24590-LAW-PCN-ENV-19-008

**Hanford Facility RCRA Permit Modification Notification Form**  
**Part III, Operating Unit 10**  
**Waste Treatment and Immobilization Plant**

Modification to the Hanford Site RCRA / WTP Dangerous Waste Permit consisting of updates to Piping and Instrumentation Diagrams for the LAW Melter Feed Process System (LFP), LAW Secondary Offgas / Vessel Vent Process System (LVP), and Radioactive Liquid Waste Disposal System (RLD). Updates performed are in accordance to WAC 173-303-830, Appendix I Modification citation number: A.3., equipment replacement or upgrading with functionality equivalent components (e.g., pipes, valves, pumps, conveyors, controls).

The purpose of this Class <sup>1</sup> modification is to provide Piping and Instrumentation Diagrams (P&IDs) for the LAW Melter Feed Process System (LFP), LAW Secondary Offgas/Vessel Vent Process System (LVP), and Radioactive Liquid Waste Disposal System (RLD) for incorporation into Appendix 9.2 of the WTP RCRA permit:

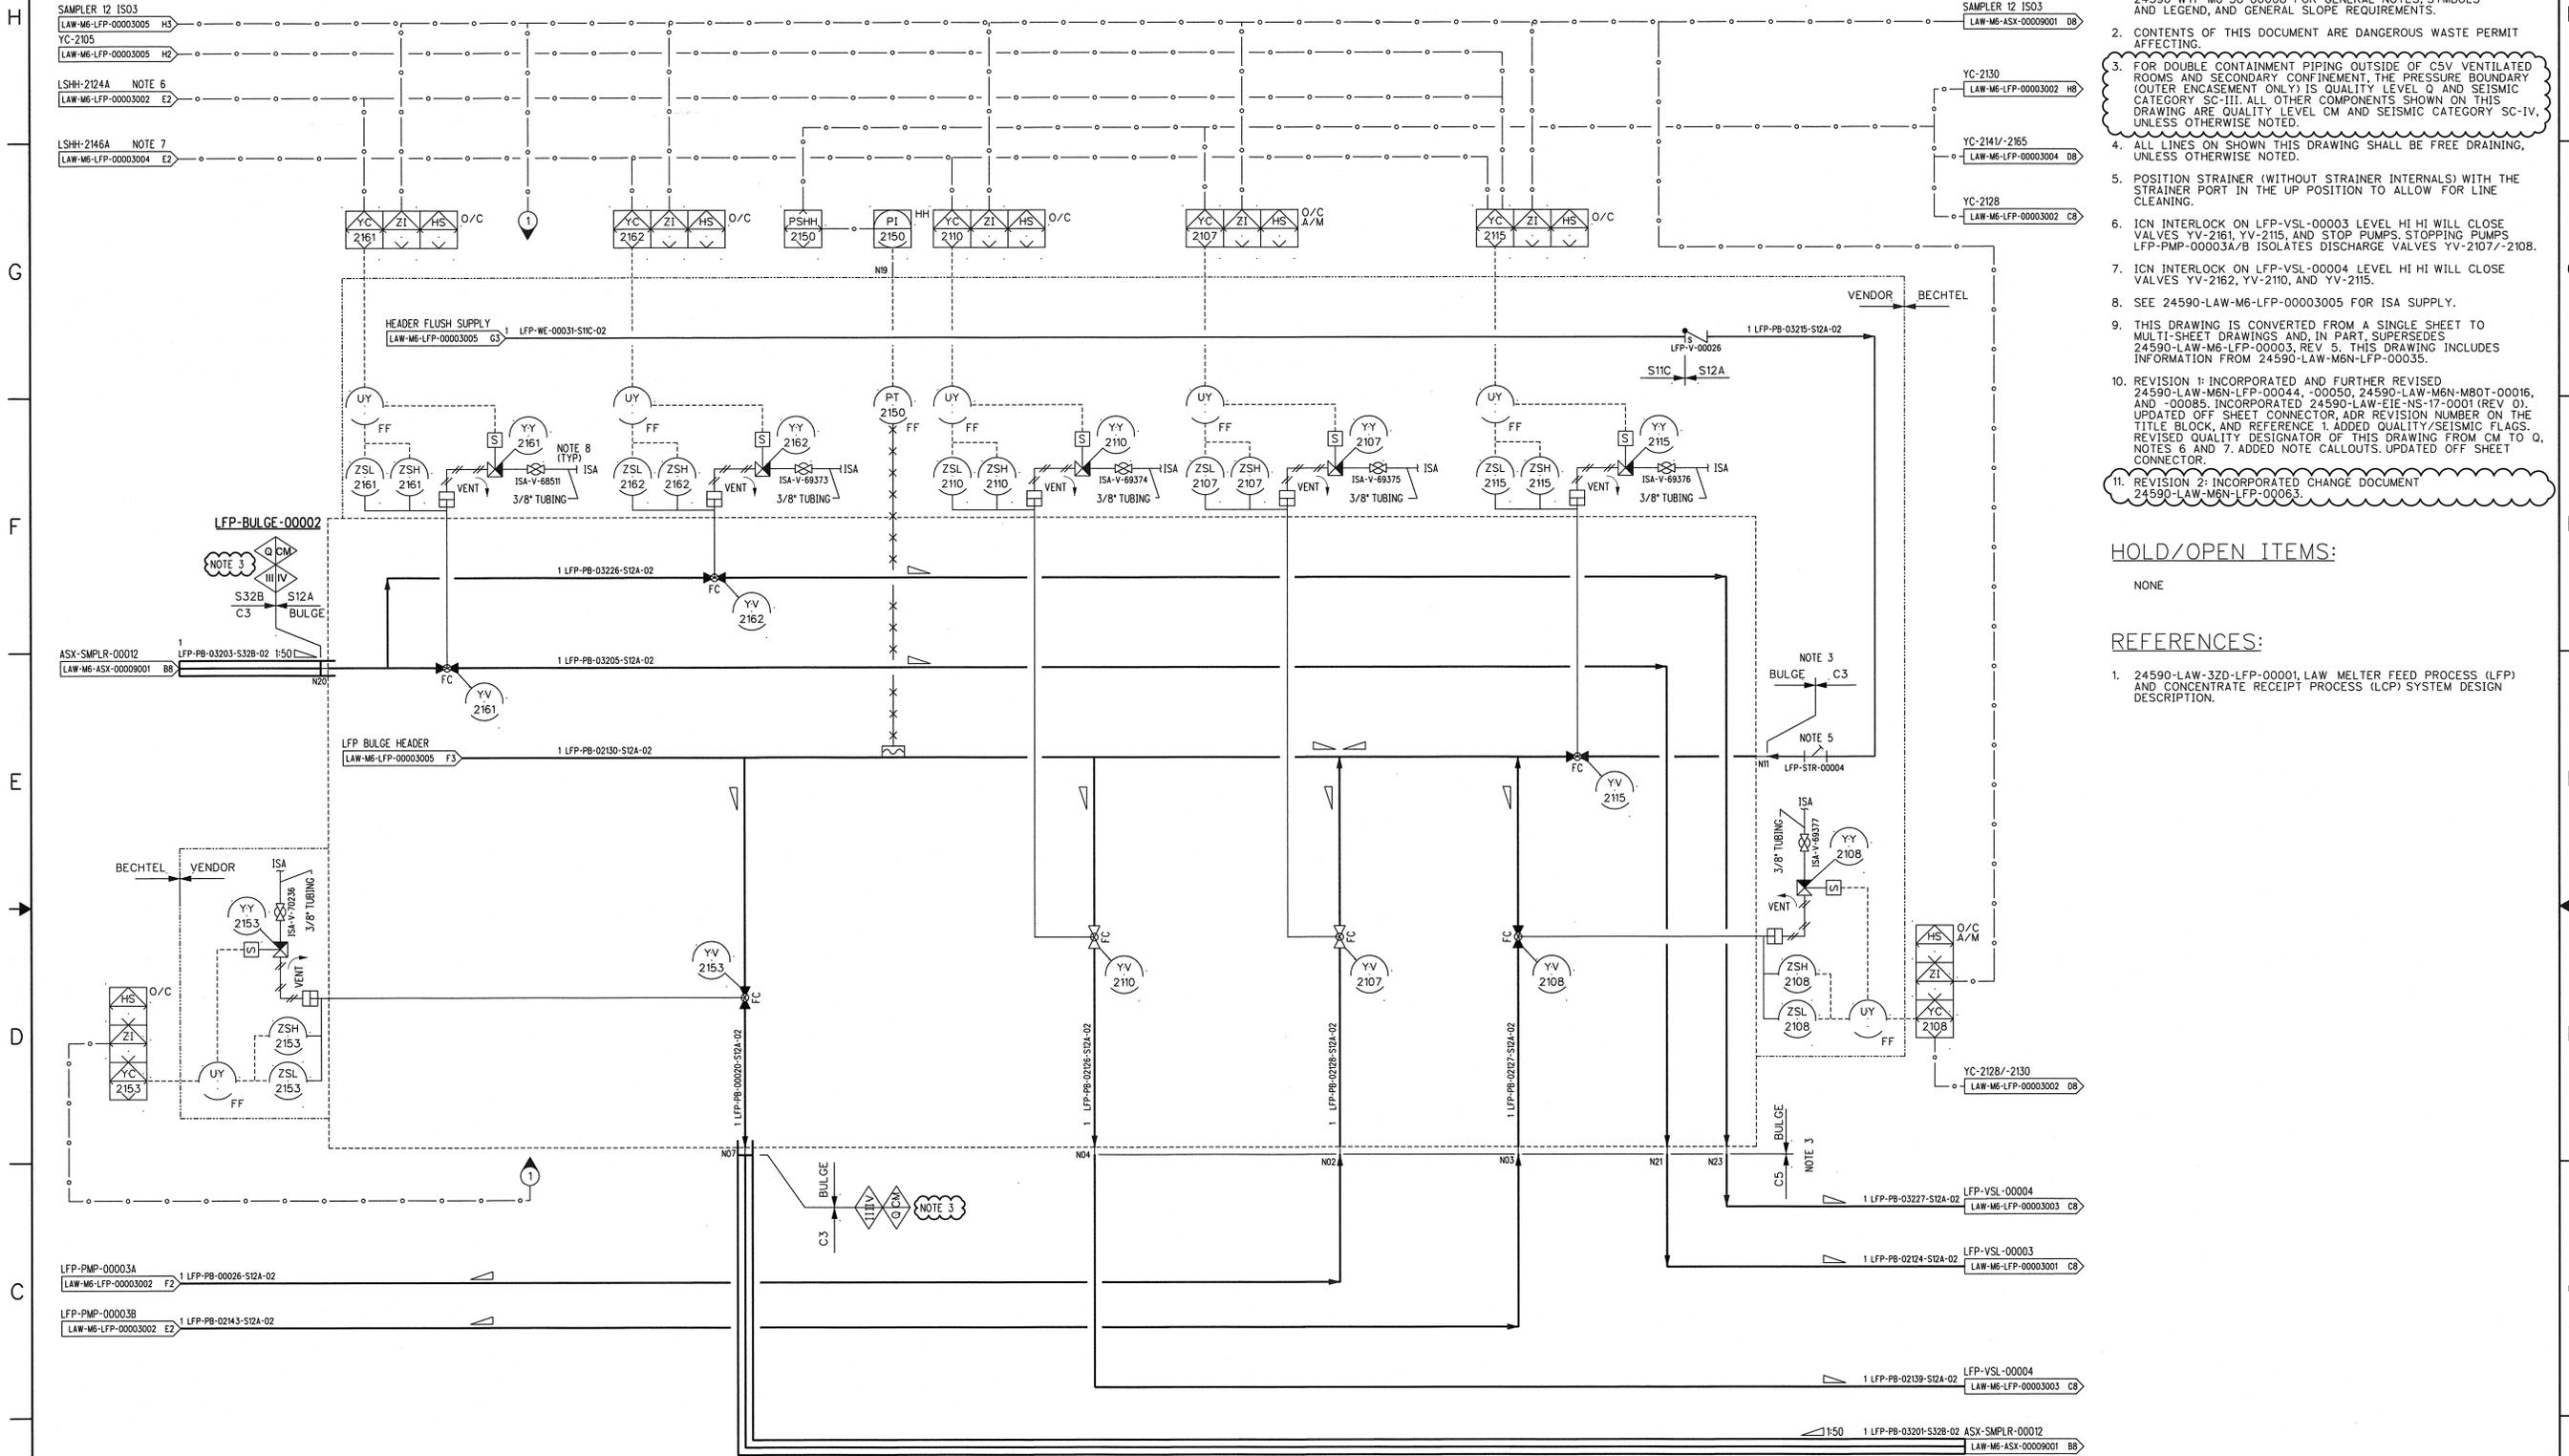
6. Significant changes incorporated into the Piping and Instrumentation Diagram (24590-LAW-M6-LFP-00003005, Rev. 1) for Melter 2 Feed Preparation and Feed Bulge LFP-BULGE-00002 of the LAW Melter Feed Process System are summarized below.

- a. Addition of Note 14, Revision 1, incorporated documentation and revised references.
  - b. Addition of Reference 1, design description of both 24590-LAW-3ZD-LFP-00001 and concentrate receipt process (LCP).

- REVISION 1 INCORPORATED CHANGE DOCUMENTS 24590-LAW-M6N-LFP-00044, -00050, -00060, 24590-LAW-M6N-M80T-00016, -00085, AND 24590-LAW-M6N-LCP-00048. REVISED SDD REFERENCE AND ADR REVISION.

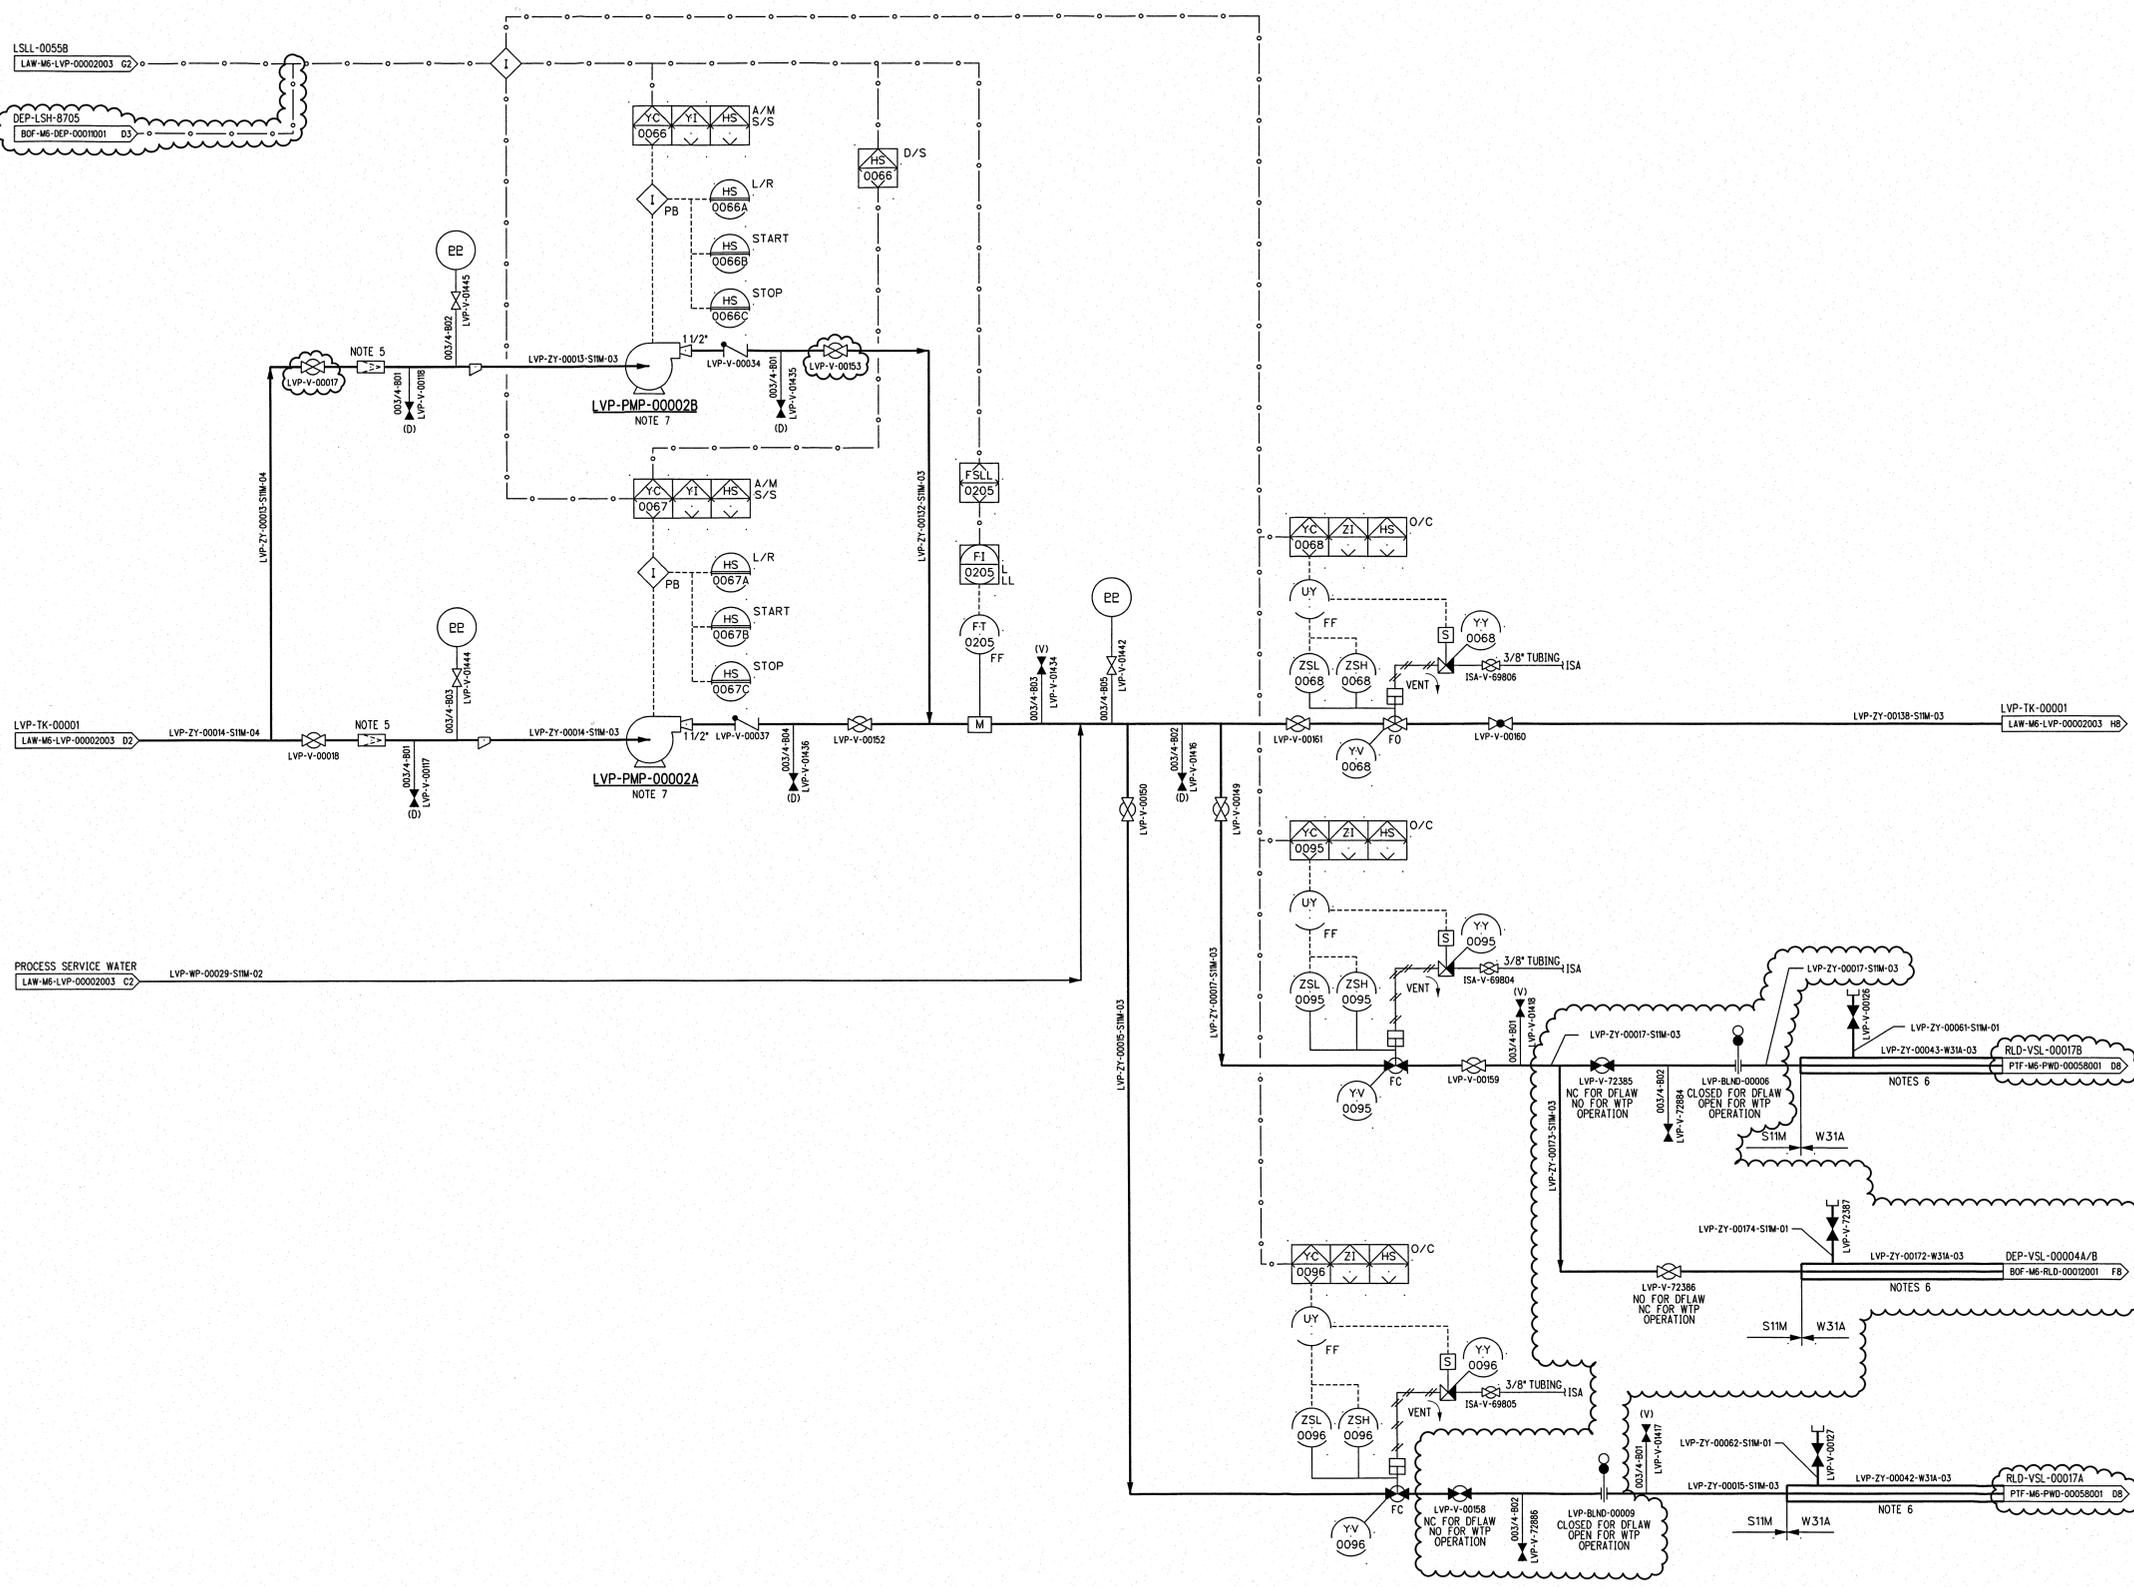
- b. Addition of Note 8, specified a pressure drop is to be minimized.

- REVISION 1: INCORPORATED 24590-LAW-M6N-LVP-00118, -00140, 24590-LAW-M6N-MB01-00033, AND INFORMATION FROM 24590-LAW-EIE-NS-17-0001, REV 0. ADDED PNEUMATIC INSTRUMENT LINE, REVISED REFERENCES AND CONTROL STRATEGY.

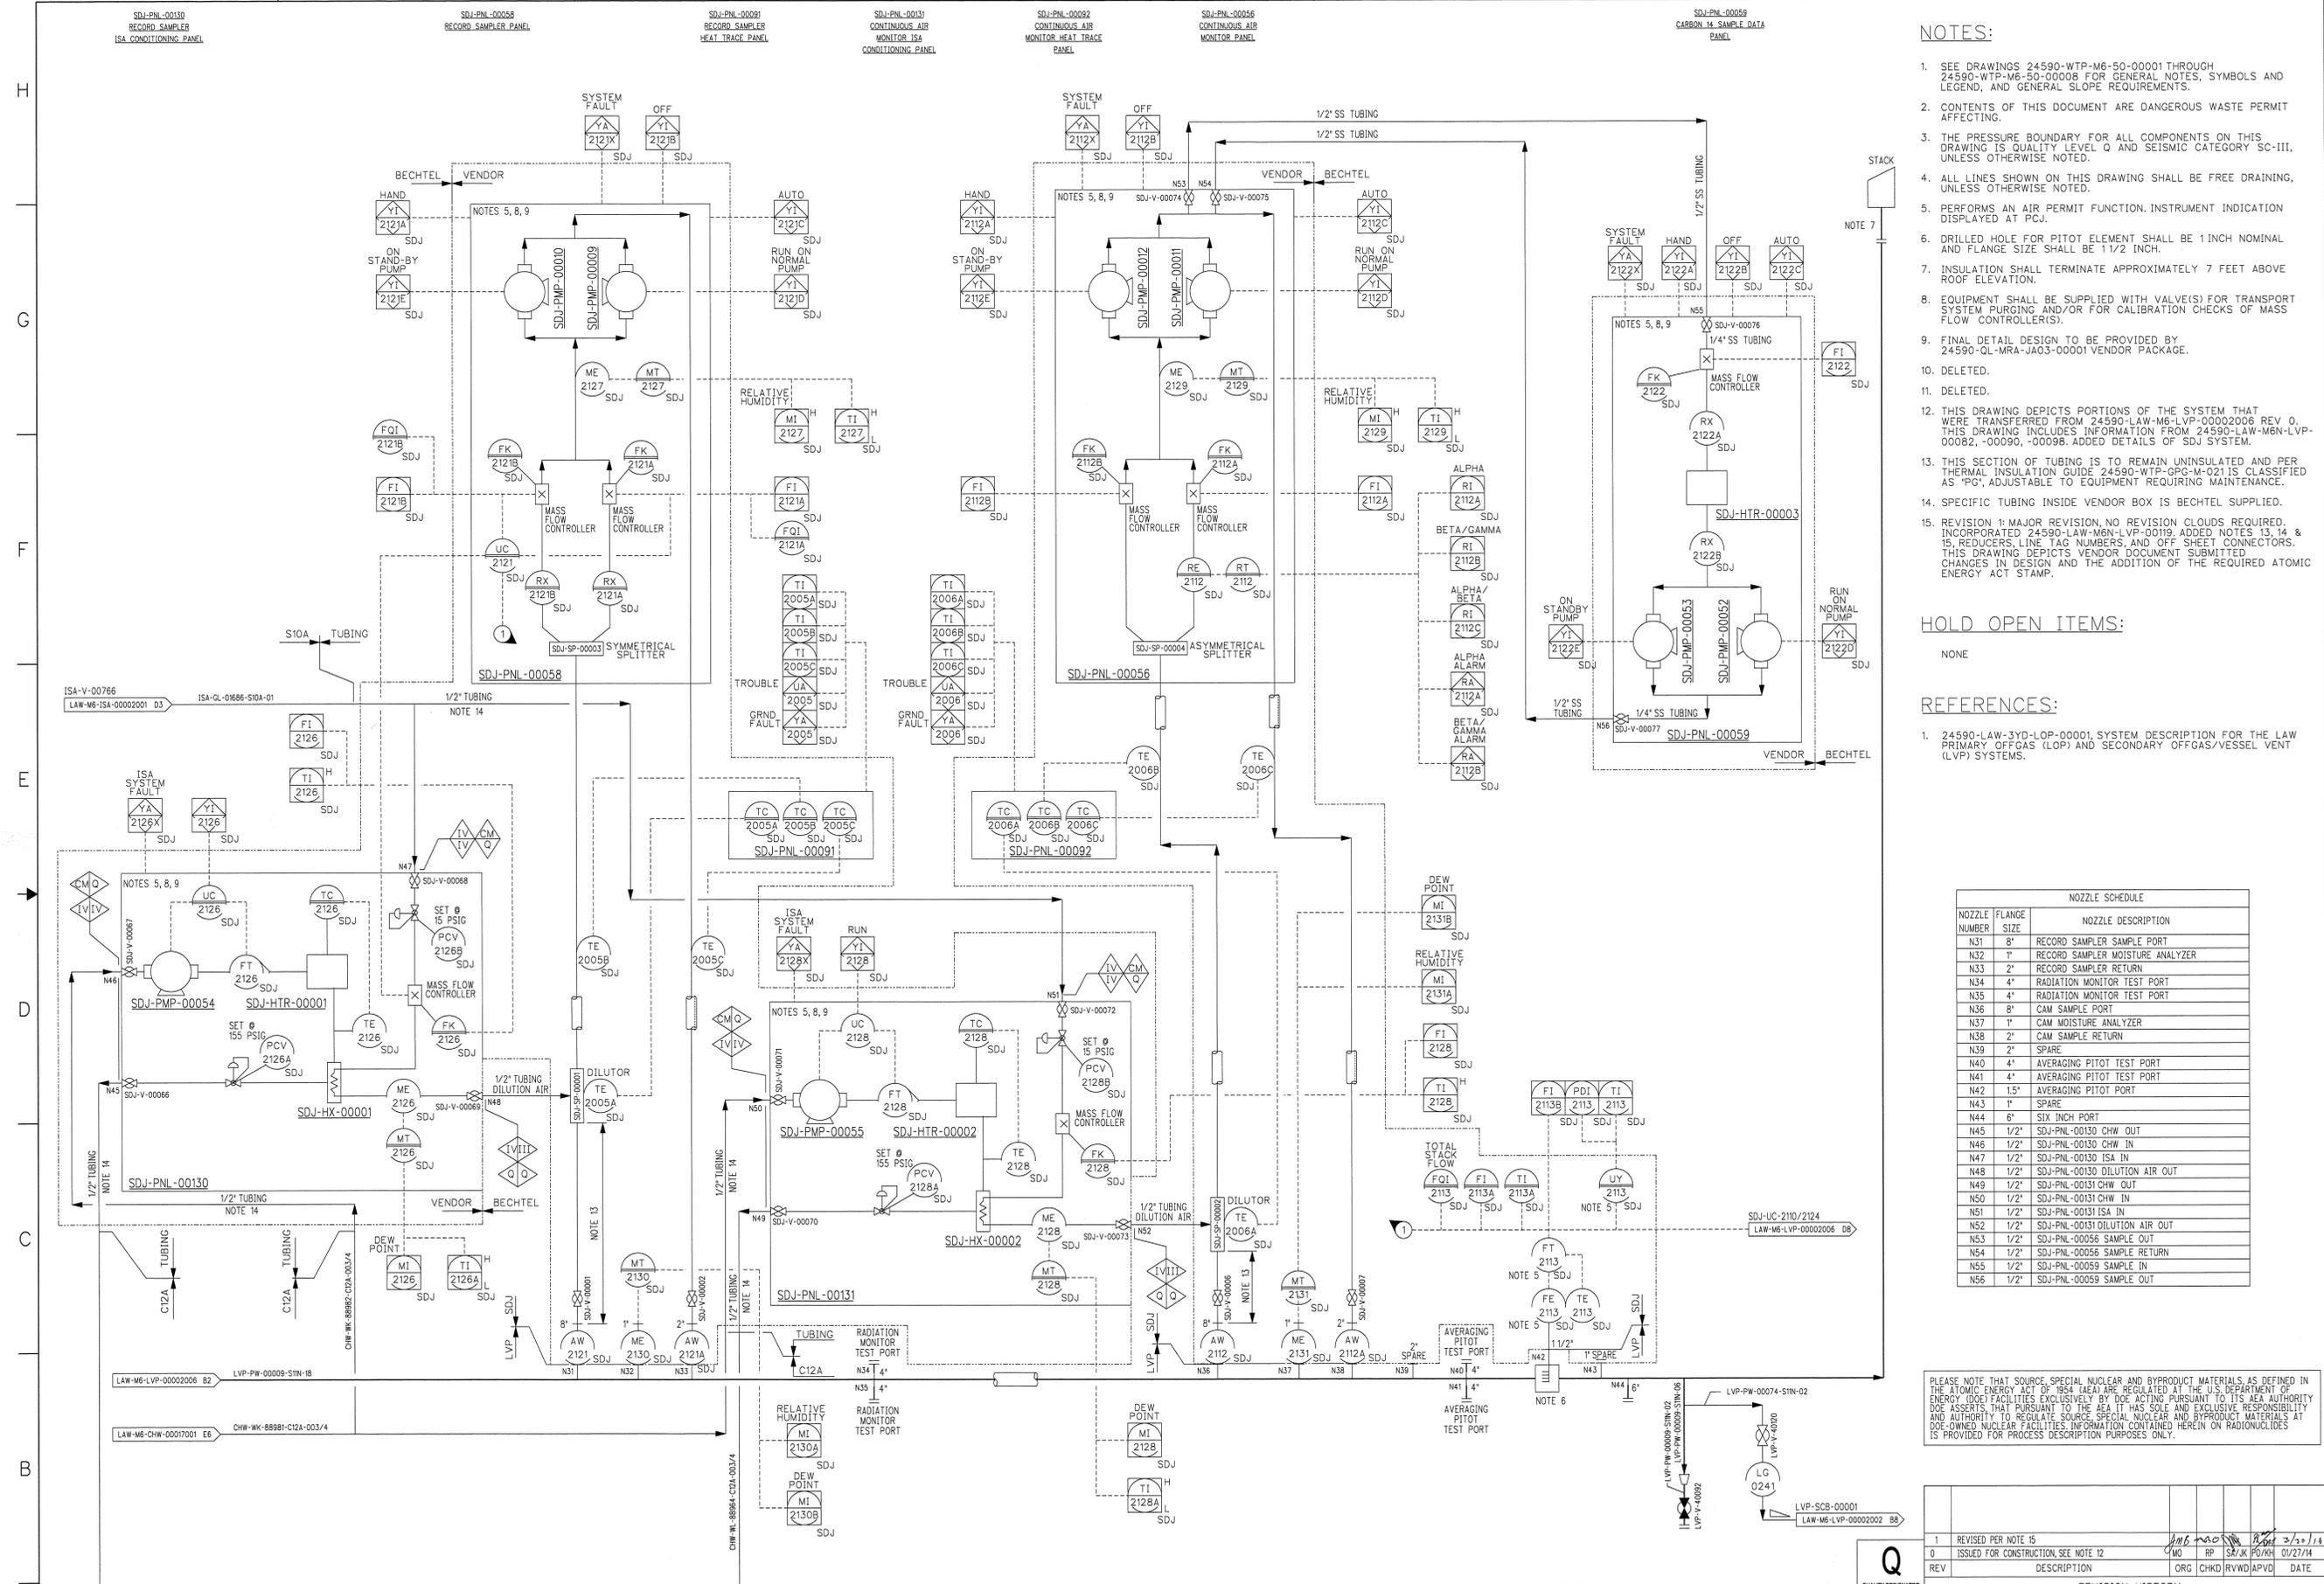
12. Delete LAW-M6N-LVP-00138 from Appendix 9.2, Design Change Notice has been incorporated into Rev 1 of P&ID 24590-LAW-M6-LVP-00002005.
13. Significant changes incorporated into the Piping and Instrumentation Diagram (24590-LAW-M6-LVP-00002007, Rev. 1) for LAW Secondary Offgas/Vessel Vent Process System Stack Discharge Monitoring System are summarized below.

- THIS REVISION INCORPORATES 24590-LAW-M6N-LVP-00122, -00138, 24590-WTP-M6N-J211-00001, 24590-BOF-EIE-J-19-0003, REVISION 0, 24590-BOF-EIE-J-19-0006, REVISION 0, 24590-BOF-EIE-M-15-0123, REVISION 0, 24590-BOF-EIE-MS-17-0021, REVISION 0, AND 24590-WTP-EIE-SYSE-16-0082, REVISION 0. UPDATED REFERENCES.
